RFQ NUMBER
708EC004

PROCUREMENT SPECIFICATIONS
NO. 012-1-Z

OPEN END CONTRACT
FIVE CUBIC YARD STAINLESS STEEL DEMOUNTABLE ABRASIVE
AND CHEMICAL SPREADER (HYDRAULIC)

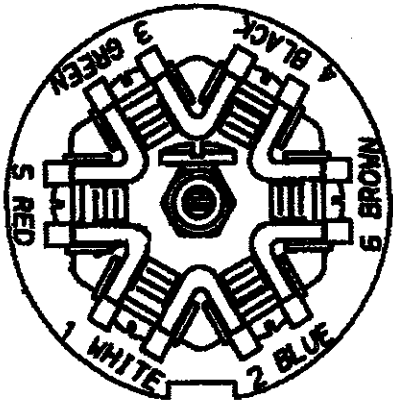
FROM:

7.13.1 The anodized 6061T6 aluminum grease manifold block shall have a minimum of six (6) ports tapped to accept three (3) 1/8 inch straight grease zerks and three (3) 1/8 inch grease Parflex hoses to provide for adequate one location greasing of the front and rear bearings and feed gate screw jack. Any unused ports are to be properly plugged.

TO:

7.13 An anodized 6061T6 aluminum or 304 stainless steel grease manifold block shall be mounted at the rear of the body incorporating the front bearing grease extension tubes, rear bearing grease fittings, and feedgate screw jack lubrication tube to allow for lubrication of the front bearings and feedgate screw jack from a single convenient location. Other fittings shall be placed at convenient location for normal maintenance.

7.13.1 The anodized 6061T6 aluminum or 304 stainless steel grease manifold block shall have a minimum of six (6) ports tapped to accept three (3) 1/8 inch straight grease zerks and three (3) 1/8 inch grease Parflex hoses to provide for adequate one location greasing of the front and rear bearings and feed gate screw jack. Any unused ports are to be properly plugged.
